# UNITED STATES PATENT AND TRADEMARK OFFICE

APPLICATION NO.	FILING DATE	FIRST NAMED INVENTOR	ATTORNEY DOCKET NO.	CONFIRMATION NO.
10/675,668	09/30/2003	Juan J. Becerra	107044-0012P1	5796
24267	7590	08/03/2006		
CESARI AND MCKENNA, LLP 88 BLACK FALCON AVENUE BOSTON, MA 02210			EXAMINER ALEJANDRO, RAYMOND	
			ART UNIT	PAPER NUMBER
			1745	
DATE MAILED: 08/03/2006

## Office Action Summary

## DETAILED ACTION

**Figure 2** clearly illustrates the fuel container design:

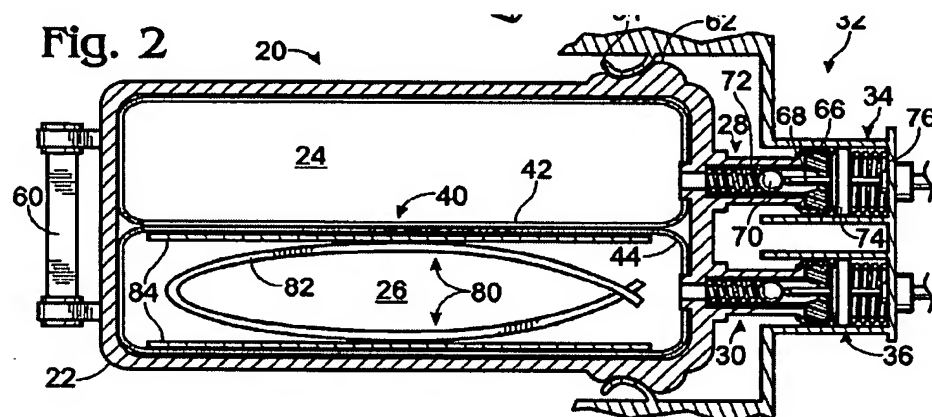
Prasad et al disclose a fuel cell system including a direct methanol fuel cell (P0025, 0045); the fuel cell includes electrode and an electrolyte disposed therebetween (P0002); a fuel supply including fuel storage area 24 configured to hold a fuel solution, a fuel solution outlet 28 configured to pass the fuel solution from the fuel storage area 24; a waste storage area 26, a waste inlet 30 configured to pass waste into the waste storage area 26 and a movable barrier 40

separating the fuel storage area 24 and the waste storage area 26 and configured to move as fuel solution is passed from the area 24 and waste solution is passed into area 26 to simultaneously decrease the volume of area 24 and increase the volume of area 26 (ABSTRACT).
